**CITY OF SOMERVILLE, MASSACHUSETTS**  
**OFFICE OF STRATEGIC PLANNING & COMMUNITY DEVELOPMENT**  
**JOSEPH A. CURTATONE**  
**MAYOR**

*HISTORIC PRESERVATION COMMISSION*

**ALTERATION TO A HISTORIC PROPERTY STAFF REPORT**

Site: 139 Central Street c. 1889 William Veazie Rowhouses  
Case: HPC 2015.068 Single Building Local Historic District

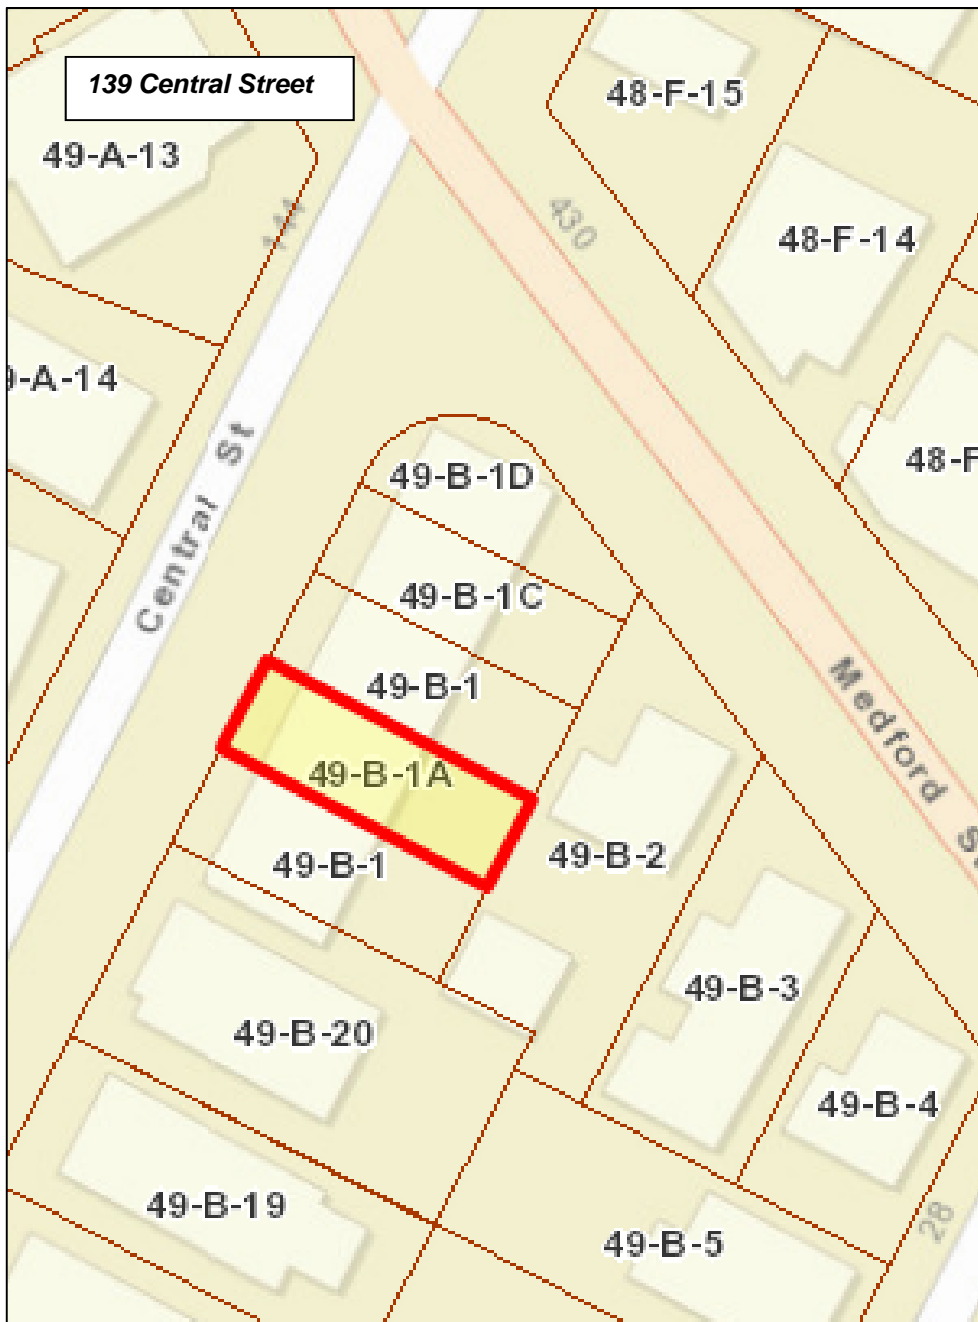
The window opening will be altered from its existing condition. The existing window is not original. There will be changes to the casing style. The finish will closely match the existing windows.

1. Applicant shall obtain all appropriate building permits prior to commencing work.
2. The greenhouse window on the rear elevation of 139 Central Street may be removed.
3. The window opening may be altered to be 3' 11.5" wide x 3' 11.75" high.
4. The window shall be Marvin Integrity Wood-Ultrex Glider.
5. The window shall have the least reflective Low E2 glass with no pattern or grills.
6. If the approval differs from the plans, new plans shall be submitted to Historic Staff prior to commencing the work;
7. Historic Staff shall issue a sign-off upon completion of the project that this was done in accordance with the Certificate and approved plans.
